CROWN STREET WOLLONGONG

RTS DESIGN RESPONSE
WOLLONGONG DEVELOPMENTS NO.8 PTY LTD

RtS DESIGN RESPONSE PURPOSE

Ground Level

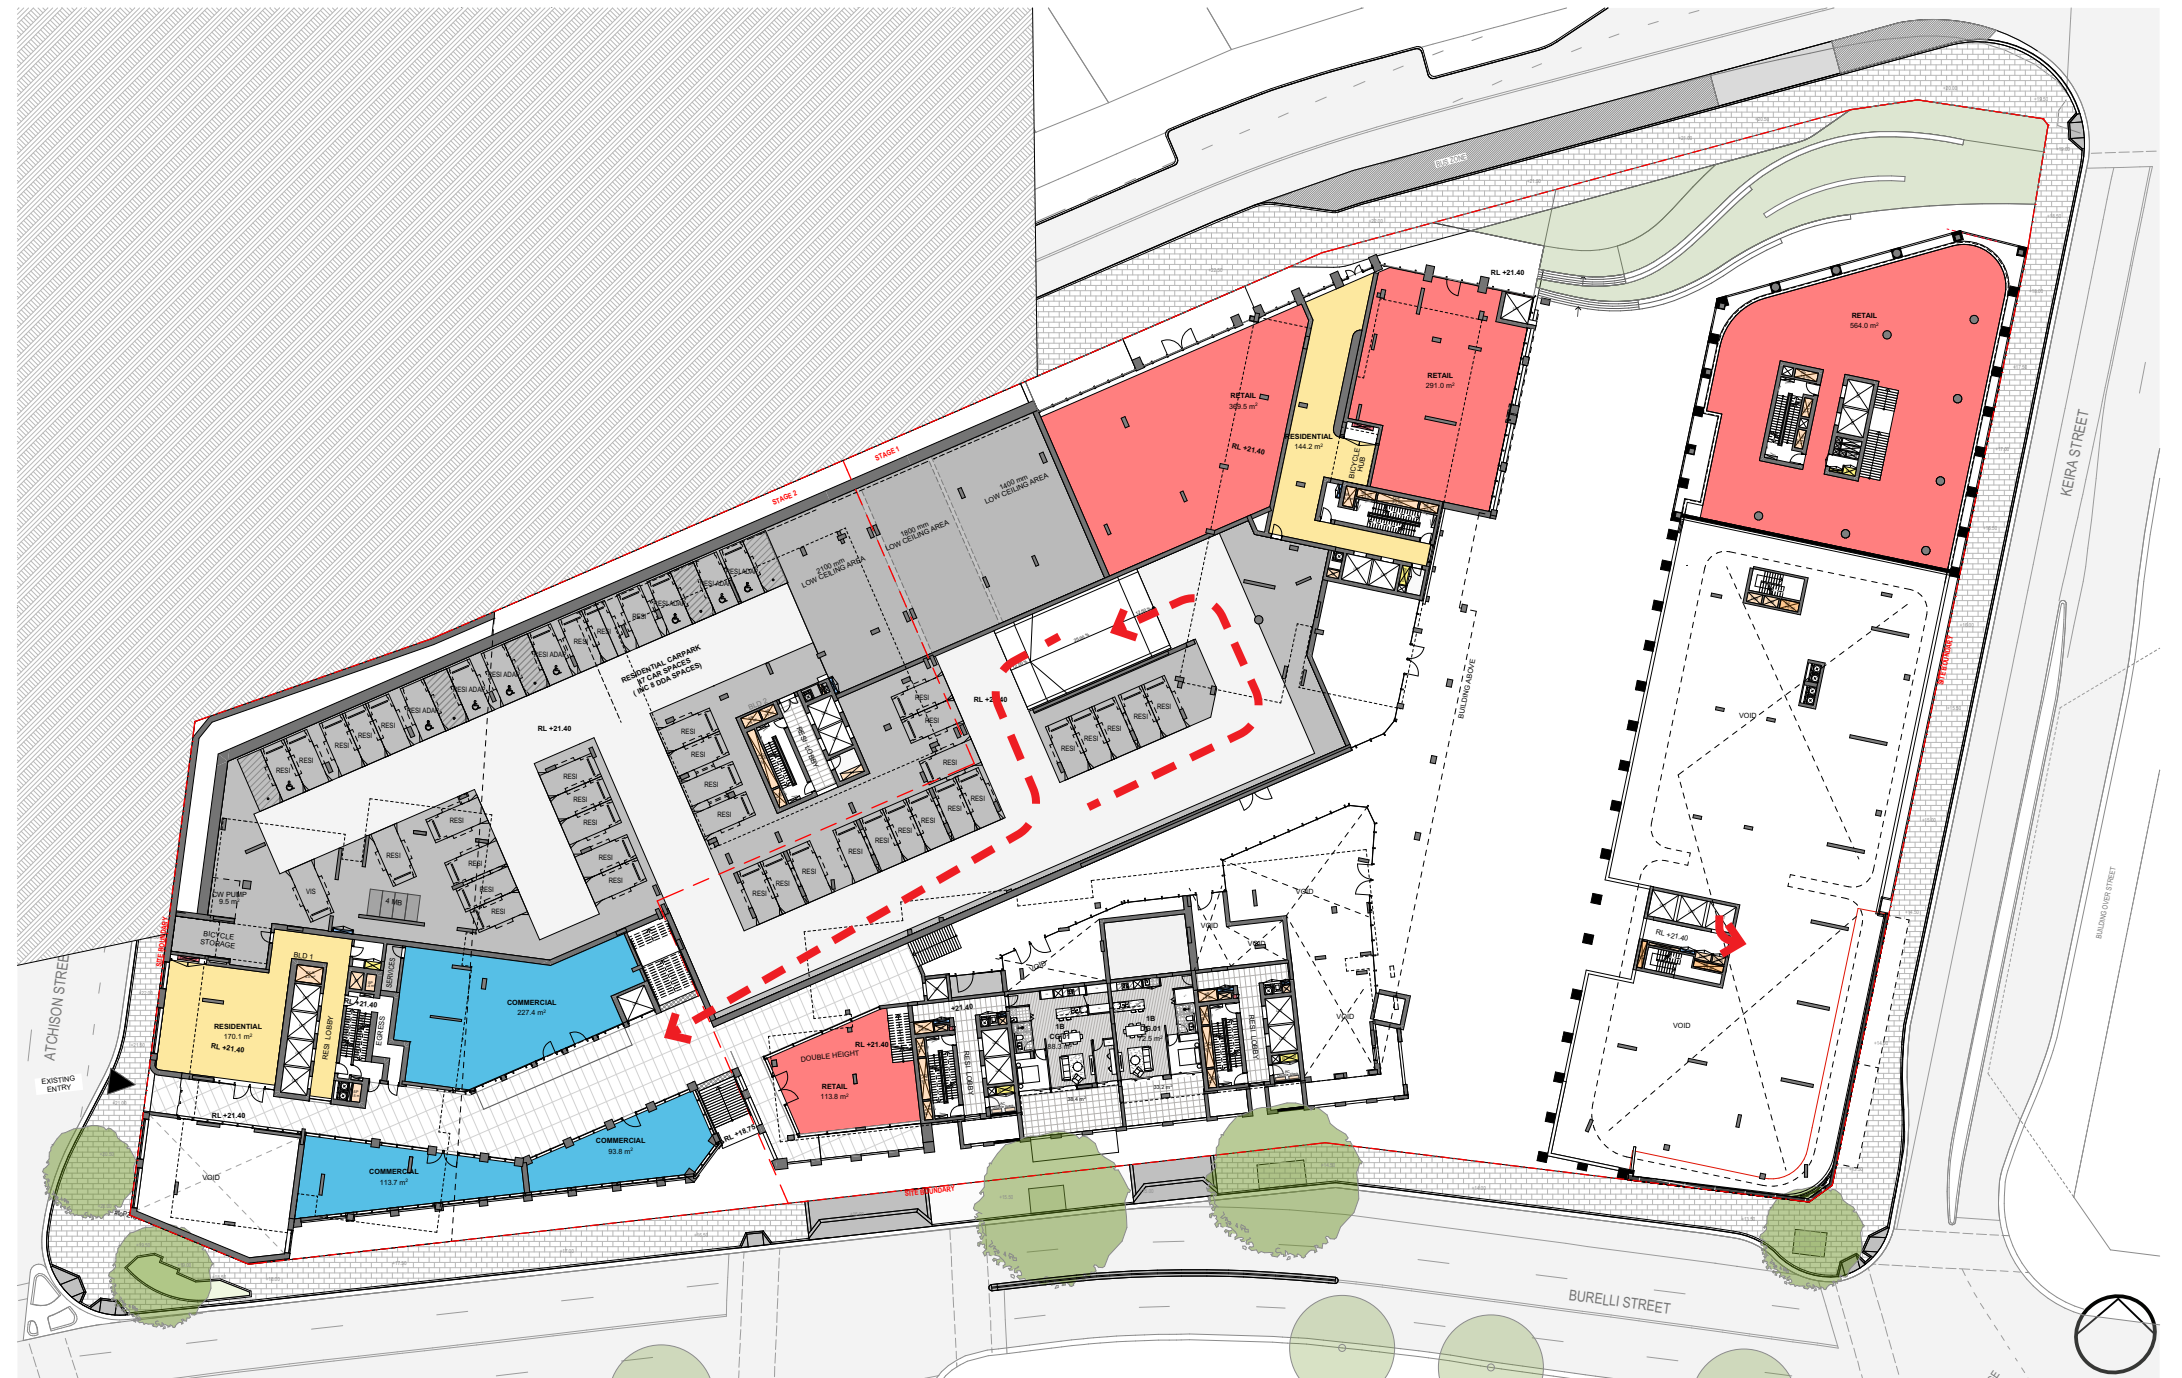
Detail delivery arrangements , including paths of travel from the loading dock to all retail, commercial, and hotel premises (without using residential lifts) and update the traffic assessment to reflect all delivery types, including hotel laundry and catering .

Paths of travel shown demonstrating paths of travel from loading through the basement.

DPHI-9

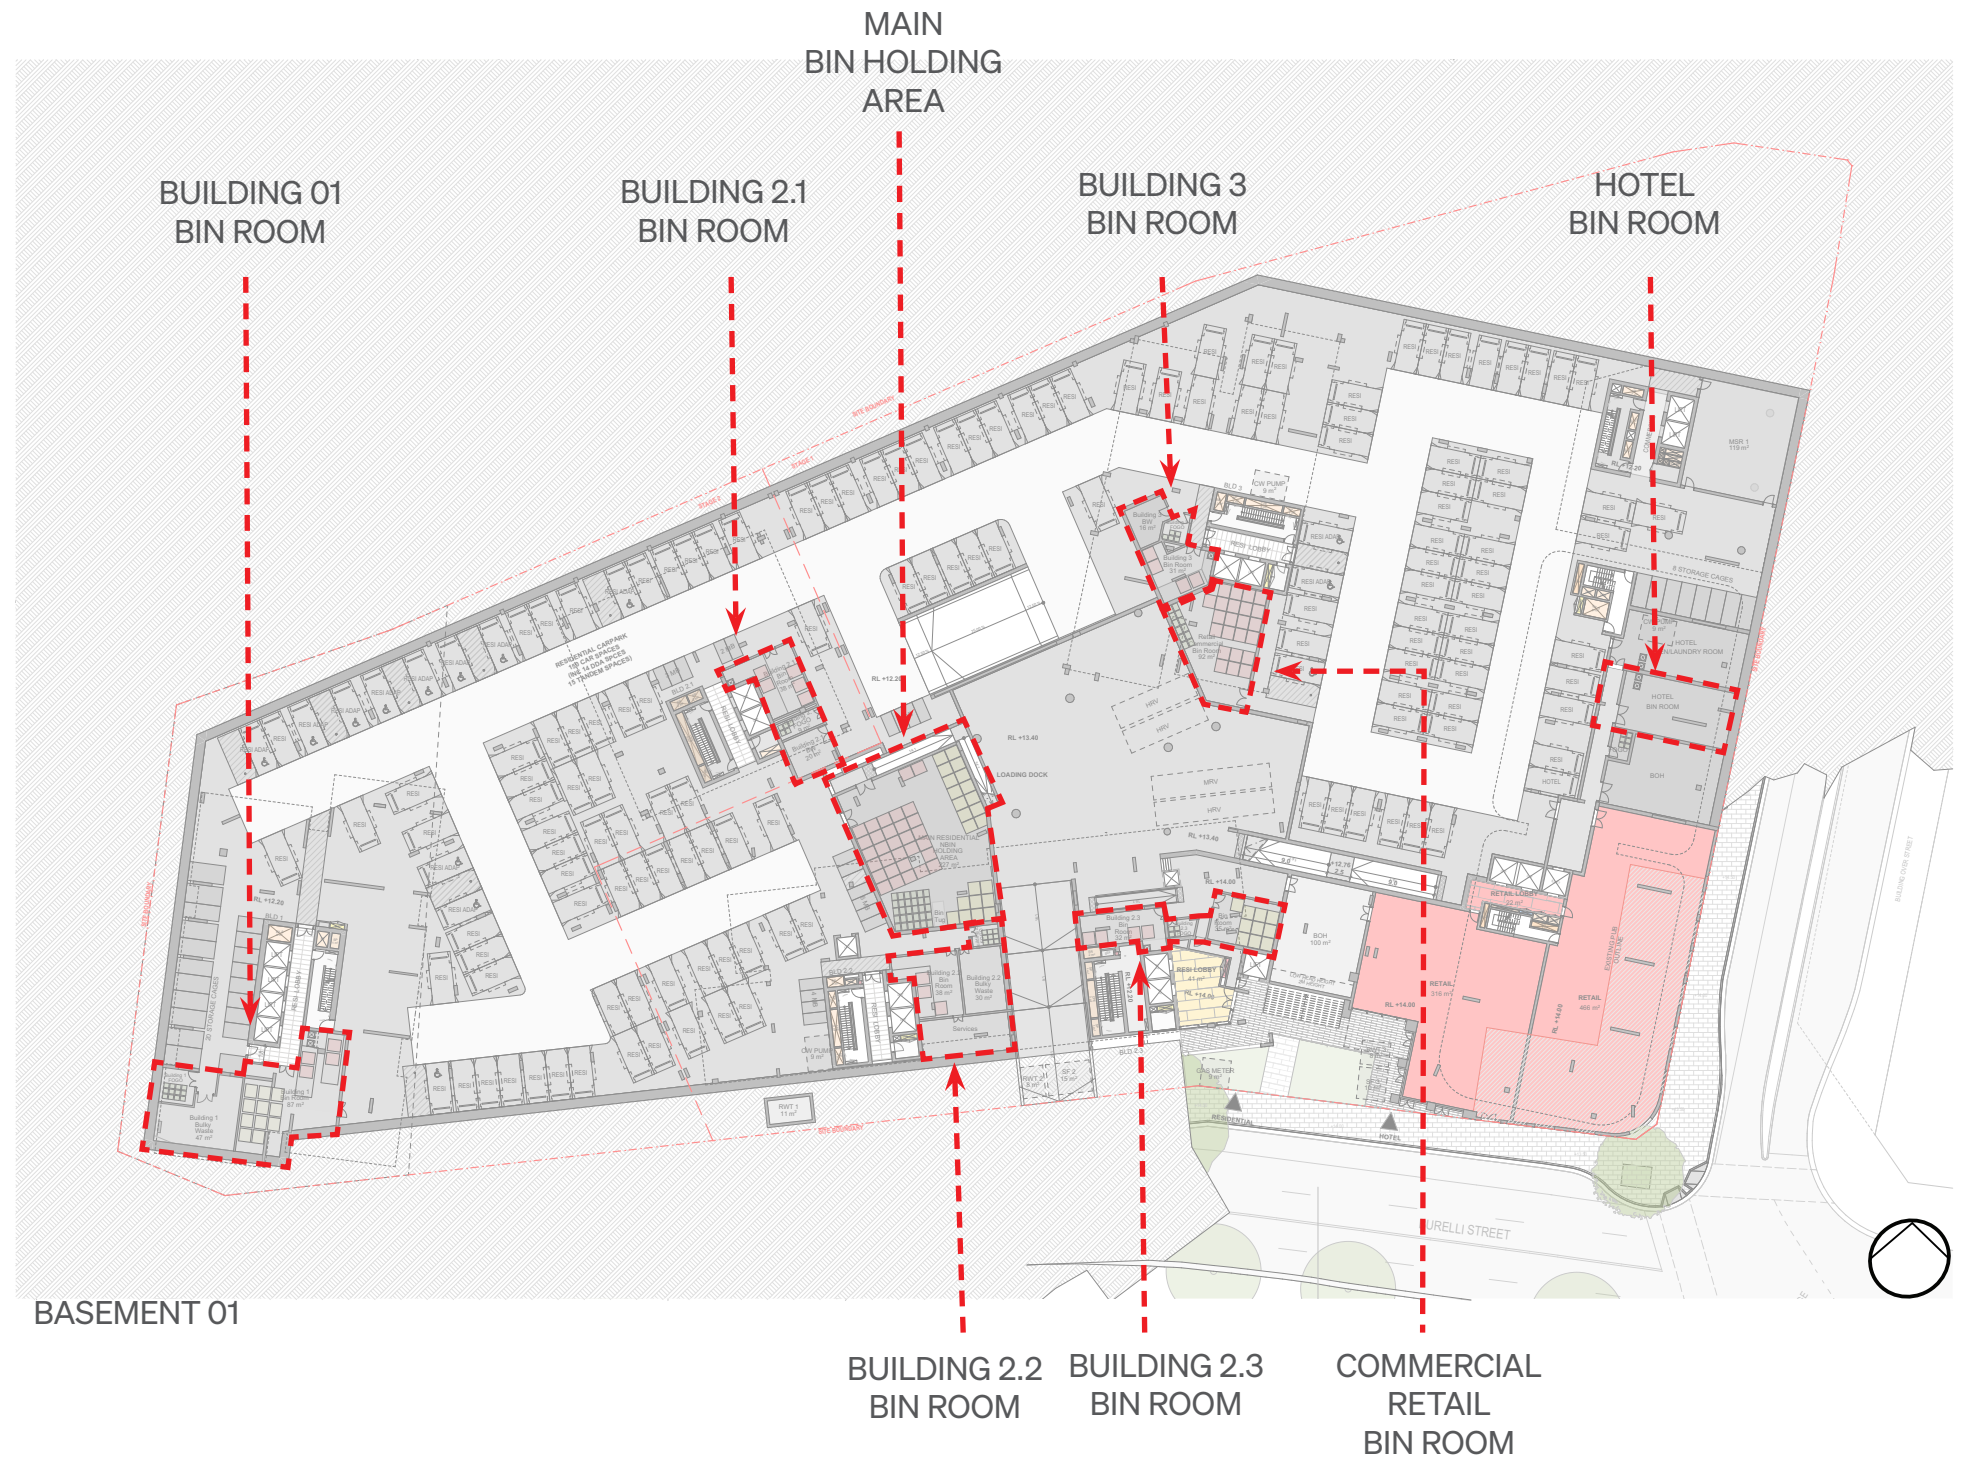
Address Council's comments regarding waste management and demonstrate that proposal provides:

- Dedicated and suitably sized on site waste storage areas for all uses (including the commercial, retail and supermarket components) and confirm that the capacity of the overall bin holding area can accommodate waste volumes at peak.

All Waste rooms have been located on Basement 01 to be on the same level as the loading dock. Refer to amended Drawing DA2001 that shows dedicated bin room for all uses.

MEZZANINE LEVEL

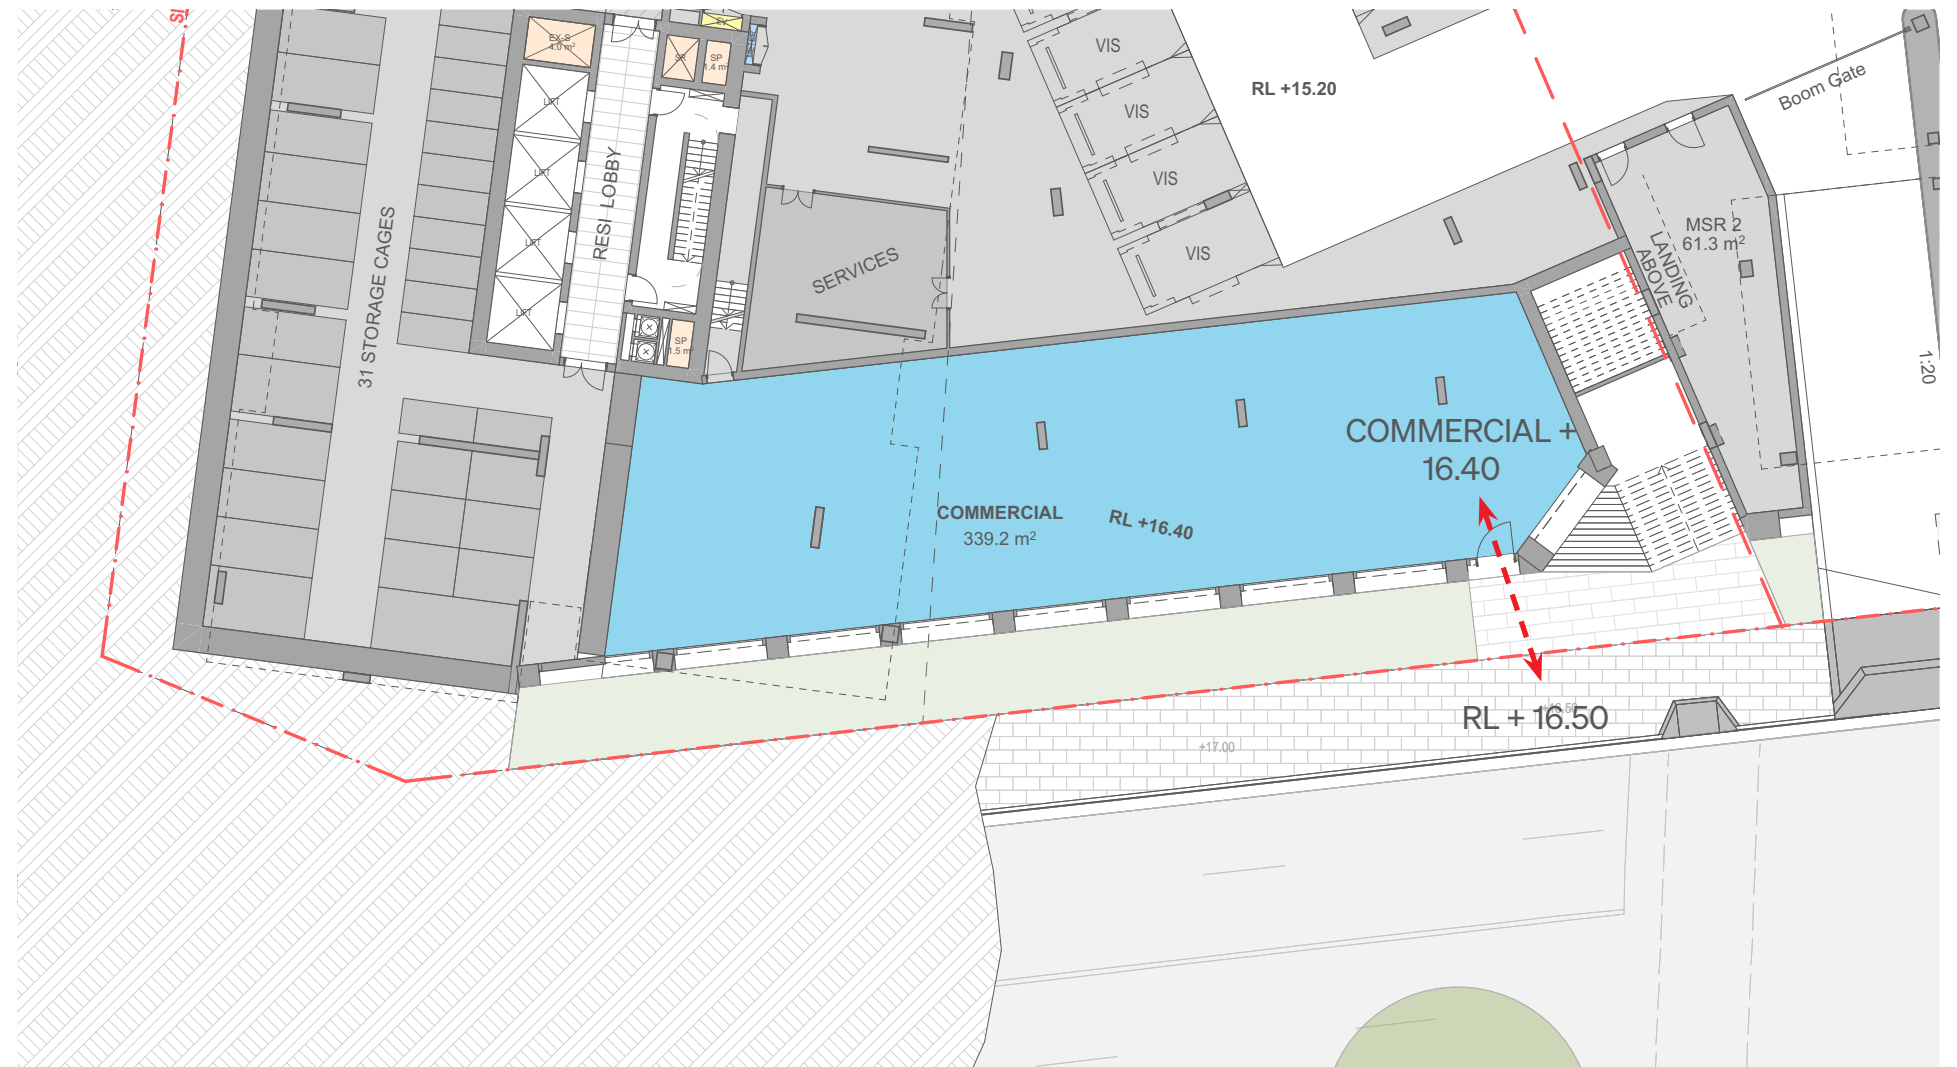
Demonstrate and accessible path of travel can be provided

- to the commercial tenancy located on the south -western corner of the burelli street frontage

Drawings amended demonstrating accessible connection to tenancy located on the south -western corner of the burelli street frontage. Refer to drawing DA2002.

DPHI - 11.2 - 11.3

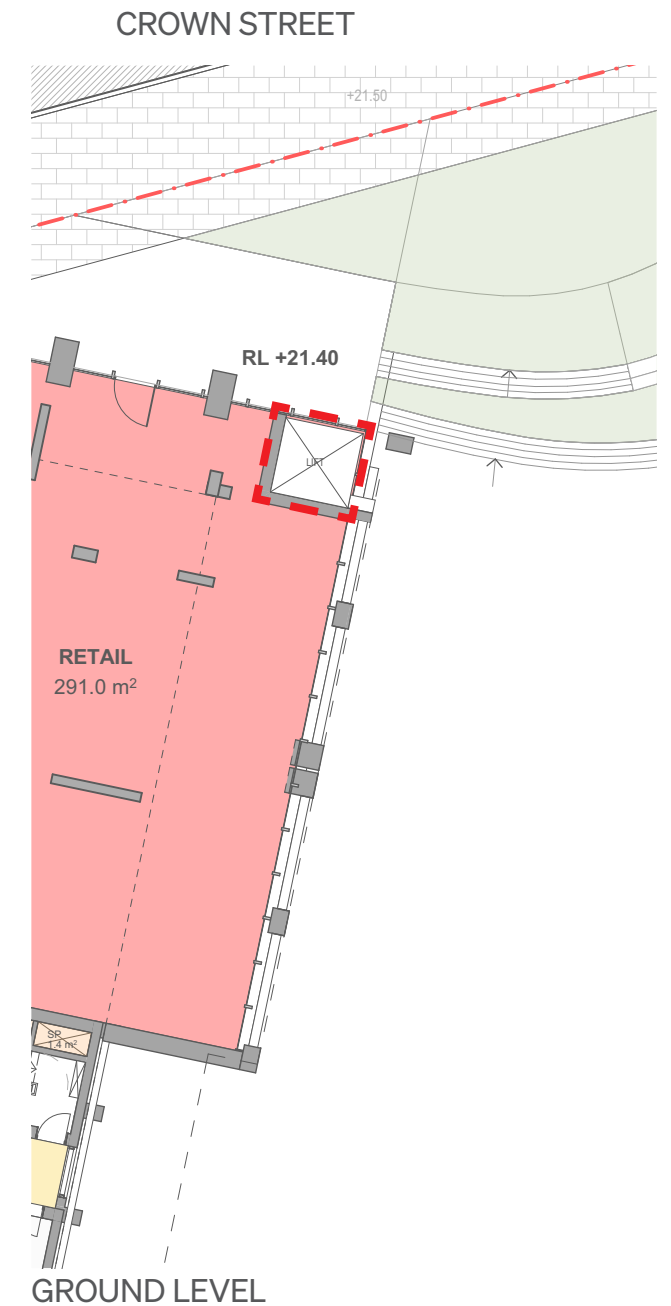
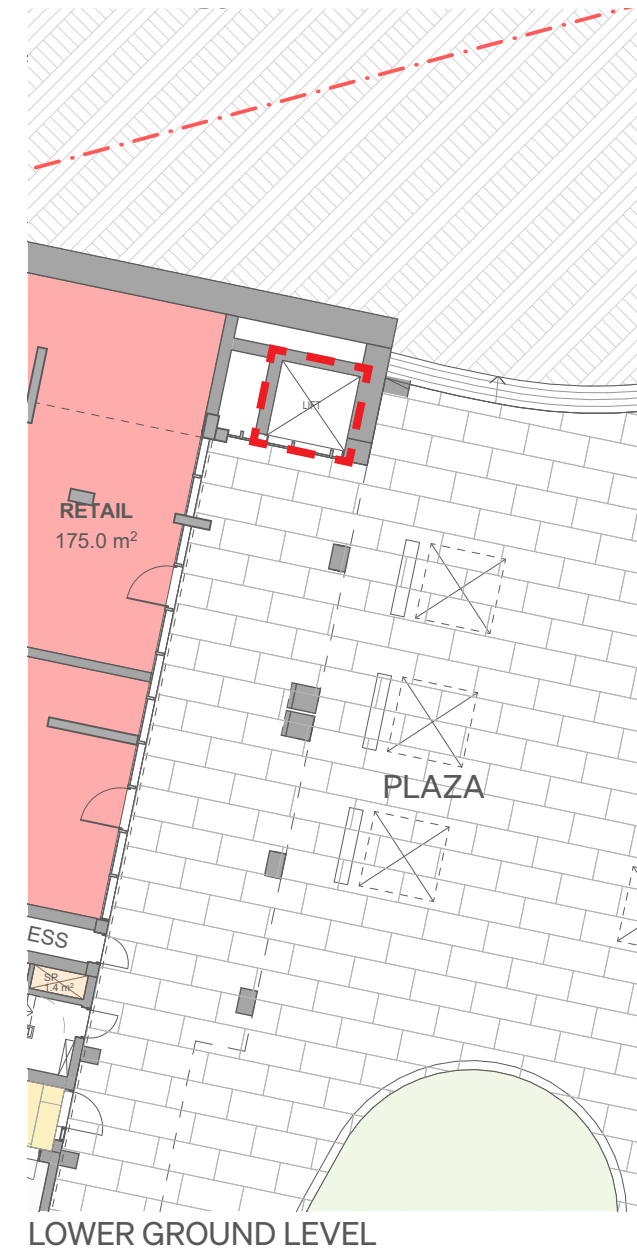
Demonstrate and accessible path of travel can be provided

- From basement car park to the retail and commercial tenancies located on the western side of the development, noting access through the residential lobbies is not supported.
- from crown street into the eastern through site link

Lift Access shown demonstrating access between Retail/commercial car park, Crown Street and Plaza. Refer to drawings DA2002 to DA2004
